Comments on Illinois Power Agency Policy Study

On January 22, 2024, the Illinois Power Agency (IPA) released a 2024 Policy Study – Draft for Public Comment, pursuant to P.A. 103-0580. SOO Green HVDC Link (SOO Green), in collaboration with its advisor PA Consulting Group, Inc. (PA), has prepared this joint memorandum to provide the following: comments on areas where the IPA’s 2024 Policy Study accurately characterizes and quantifies expected benefits that will result from SOO Green’s operation, recommendations to improve the Policy Study’s modeling assumptions and approaches to yield more accurate projections of expected benefits, and suggestions to better clarify the expected value proposition and cost of SOO Green. Where relevant, the respective party providing each comment area (SOO Green or PA) is noted.

Figure 1: Natural Gas Price Projection Comparison

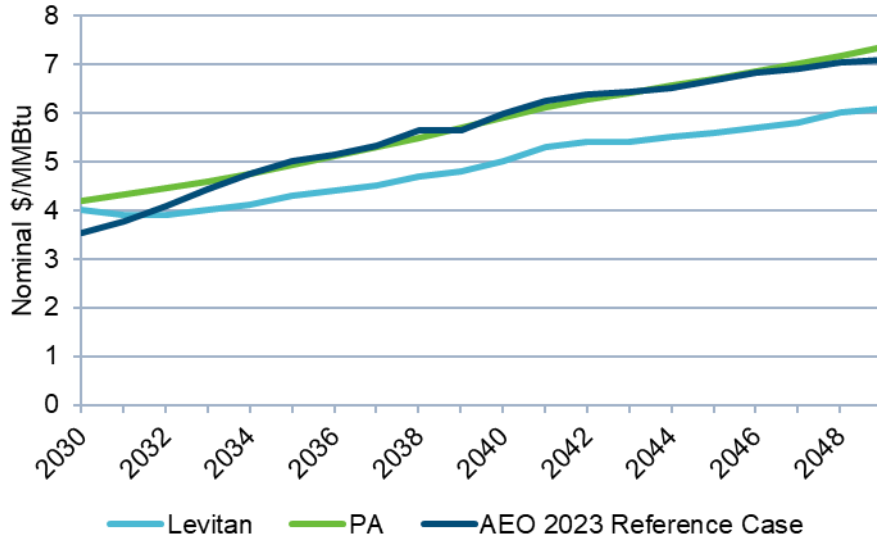
As a result of relying upon Henry Hub futures through year 2035, Levitan's long-term projection of natural gas prices in PJM (including the ComEd zone) is inappropriately low. Figure 1 below shows Levitan's projection of ComEd zone natural gas pricing²⁵ relative to PA's projection used in its production cost modeling, alongside the EIA's 2023 AEO Reference Case projection.²⁶ From 2032 onwards, Levitan's projection is substantially lower than the 2023 AEO Reference Case, with the difference averaging approximately \$0.90/MMBtu through 2049.

With these considerations in mind, we recommend that Levitan re-run their Production Cost Modeling study using long-term natural gas price projections that are based on fundamental modeling rather than NYMEX futures. A reasonable, publicly available source for updated natural gas price projections to be used in Production Cost Modeling would be the EIA’s 2023 Annual Energy Outlook Reference Case.

Figure 2: Fuel Portion of Electric Energy Dispatch Cost Comparison

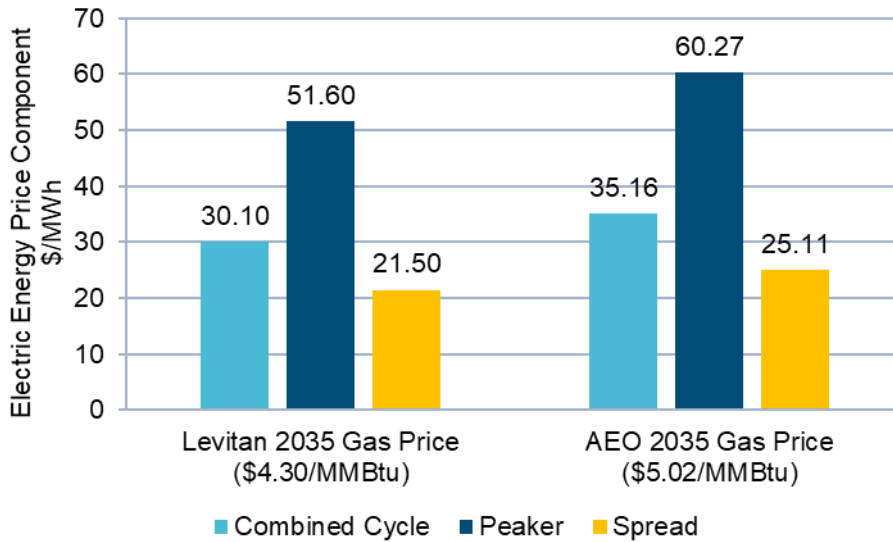
Assumed lower natural gas prices result in a lower spread in electric energy dispatch costs between more efficient and less efficient generation resources. Figure 2 below shows the difference in the fuel portion of gas-fired generator dispatch costs for a hypothetical combined cycle generator (7 MMBtu/MWh heat rate) and peaker (12 MMBtu/MWh heat rate) using Levitan’s year 2035 projected ComEd delivered natural gas price and AEO Reference Case-derived year 2035 ComEd delivered natural gas price. The illustrative spread in dispatch costs between hypothetical combined cycles and peakers is approximately 17% higher between the AEO-derived natural gas price assumption and Levitan’s artificially low natural gas price assumption.

Figure 3: Illustrative Representation of Wholesale Energy Cost Savings Using Different Gas Prices

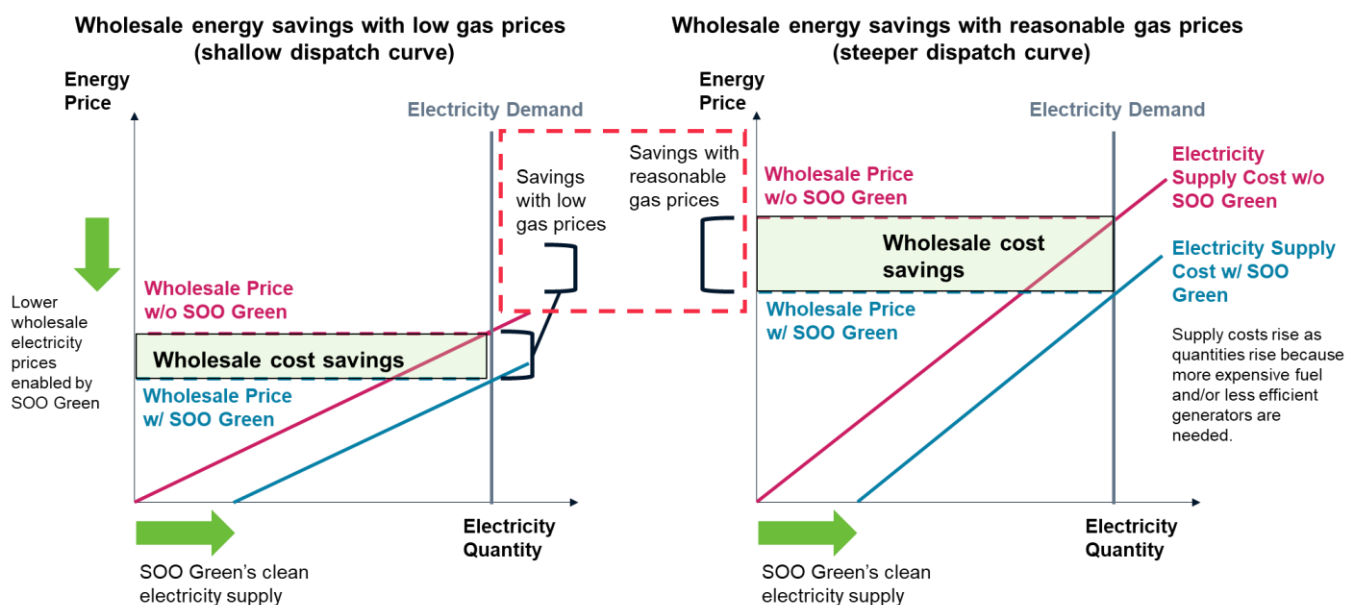
Figure 3 below illustrates how low natural gas price assumptions can result in artificially “shallow” generator dispatch merit order curves (i.e., lower spread between more- and less-efficient generators) relative to more reasonable natural gas price assumptions, which result in steeper dispatch curves. With low natural gas price assumptions and shallow dispatch curves, the projected difference in wholesale energy prices (and associated wholesale energy cost savings) caused by SOO Green’s clean energy deliveries ends up substantially lower than would be expected with more reasonable natural gas price assumptions.

Figure 4: ComEd Zone Energy Demand Forecast by Source

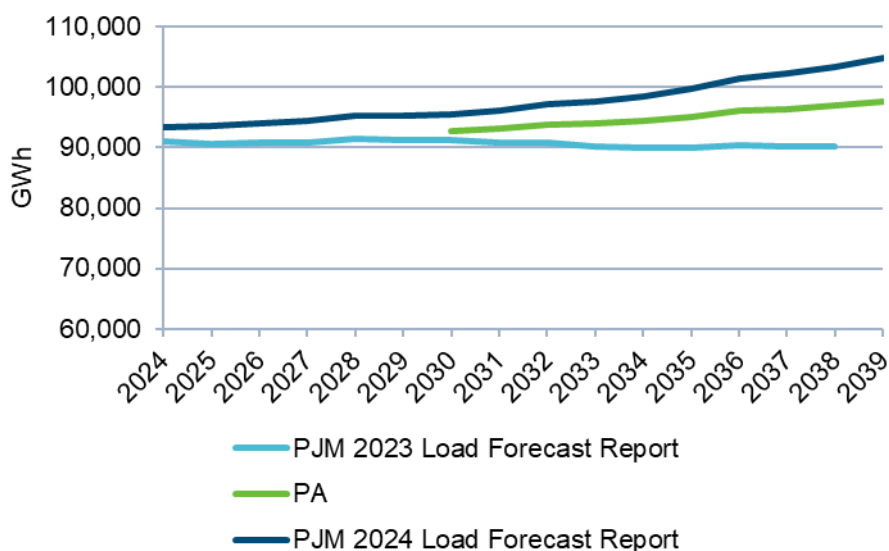
First, from Levitan’s description of their PJM electricity demand assumptions, it is unclear how Levitan arrives at the extrapolated ComEd zone electricity demand forecast shown in Figure 3: Annual Energy Forecast, PJM of their study.²⁷ Per PJM’s 2023 Load Forecast Report, annual energy demand (accounting for the impacts of distributed solar generation, distributed battery storage, and plug-in electric vehicles) in the ComEd zone is projected to remain roughly flat, rising slightly from 2023 (90,558 TWh) to 2028 (91,373 TWh) before declining to 90,253 TWh by 2038. The 5-year, 10-year, and 15-year CAGRs for this demand outlook are 0.0%, -0.1%, and 0.0%, respectively (i.e., flat). However, Figure 3 in Levitan’s Production Cost Modeling study shows ComEd zone demand declining at a CAGR of approximately -0.5% from 2038 through 2050²⁸ It is unclear how Levitan arrived at such a rapid long-term demand decline assumption, which does not align with trends demonstrated in PJM’s 2023 Load Forecast Report.

Furthermore, although PJM’s 2024 Load Forecast Report had not yet been released at the time Levitan performed their study, it is now available and there are critical changes in the 2024 Load Forecast that should be considered. The 2024 Load Forecast Report includes much more rapid ComEd zone demand growth projections than the 2023 Load Forecast Report. Whereas the 2023 Load Forecast projected roughly flat energy demand in the ComEd zone, the 2024 Load Forecast more appropriately accounts for factors like accelerated growth in electric vehicle charging demand, which are more in line with expected trends given Illinois state policy goals for reducing emissions from transportation. Figure 4 below shows a comparison of ComEd zonal energy demand forecasts from:

Differences in zonal electricity demand forecasts can have a significant impact on projected wholesale energy cost savings impacts. Assuming flat or declining zonal electricity demand growth, along with a significant influx

With these considerations in mind, *we recommend that Levitan re-run their Production Cost Modeling study using more up-to-date demand forecast assumptions from the 2024 PJM Load Forecast Report.*

Figure 5: Illinois Coal and Natural Gas-Fired Power Plants and Disadvantaged Communities

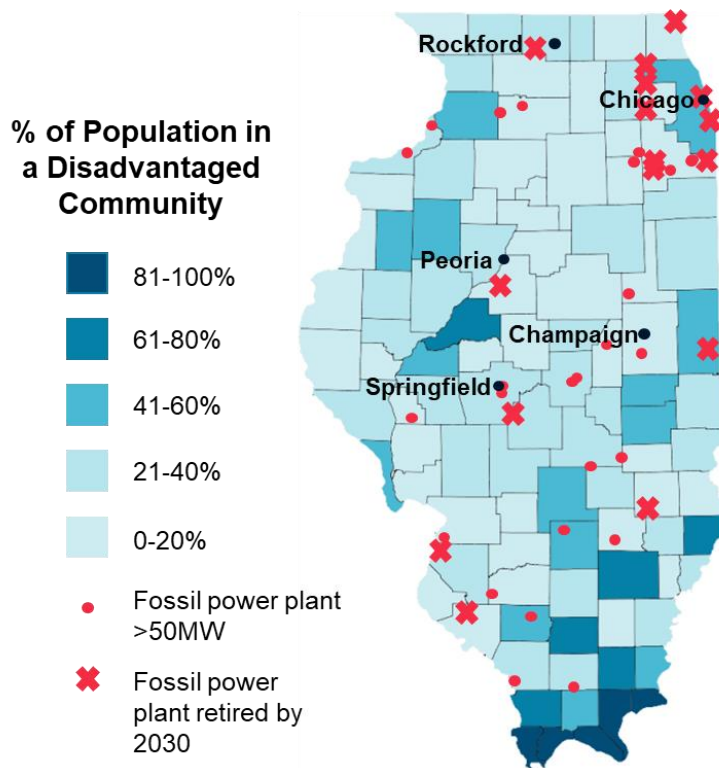
Renewable electricity delivered by SOO Green will have a direct and lasting impact by providing replacement for power currently generated by fossil fuel plants slated for retirement under CEJA and currently located in EJ communities. Based on the ILSFA EJ map, many of the fossil fuel plants slated for retirement by 2030 are in the vicinity of EJ communities in the following ten Illinois counties: Cook, DuPage, Lake, Will, and Winnebago (in PJM) and Christian, Jasper, St. Clair, Tazewell, and Vermillion (in MISO). Furthermore, several of the fossil-fired power plants that would dispatch less frequently after 2030 due to SOO Green’s clean electricity delivery are located in counties that host significant populations living in census tracts identified as disadvantaged communities (DAC). Figure 5 shows a map of fossil-fired power plants grouped into those that are expected to retire in 2030, for which SOO Green would help provide replacement power, and those expected to continue operating beyond 2030, which would see emissions reduced as a result of SOO Green’s deliveries. These plants are mapped relative to Illinois counties represented by share of the population living in identified DACs.

With this in mind, we request that the IPA’s discussion of the EJ impacts associated with SOO Green include consideration and quantification of the generator emissions reduced by SOO Green for units located in or near disadvantaged communities.

Figure 6: Generator Emission Reductions and DAC Populations in Illinois Counties (2030-2039)⁵⁰

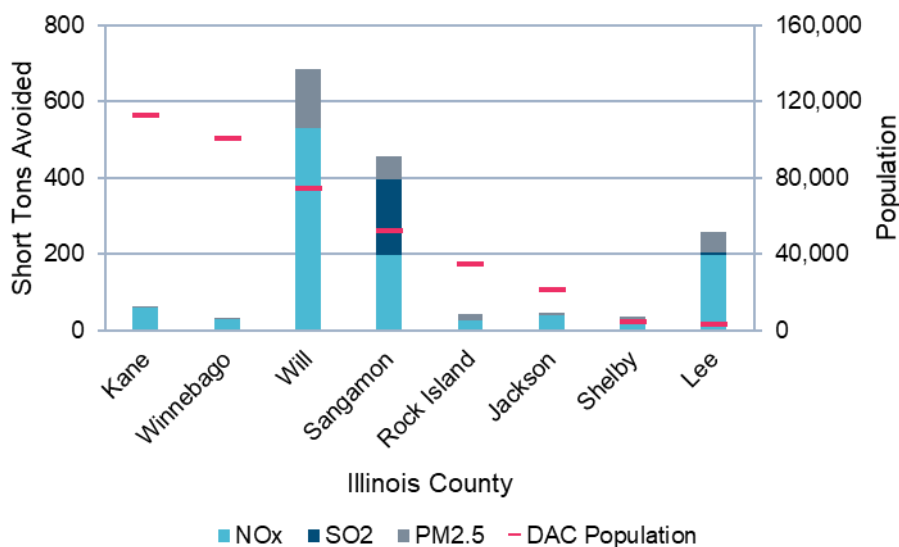
Additionally, Figure 6 below shows fossil-fired generator emission reductions (in short tons) for units located in Illinois counties that feature one or more census tracts identified as DACs, alongside the population living in DAC census tracts in each county. Harmful pollutant reduction impacts are particularly noteworthy in Will and Sangamon counties, where PA projects SOO Green would enable the reduction of over 700 tons of NO_x emissions, approximately 200 tons of SO₂ emissions, and over 200 tons of PM_{2.5} emissions in the first 10 years of operation (2030-2039), and where over 125,000 Illinois residents live in census tracts identified as DACs. Furthermore, based on the federal CEJST tool, we have identified 673 additional DAC census tracts (population 2.4 million) in Illinois that are outside the workforce corridor, but within PJM’s territory where SOO Green will deliver renewable power.
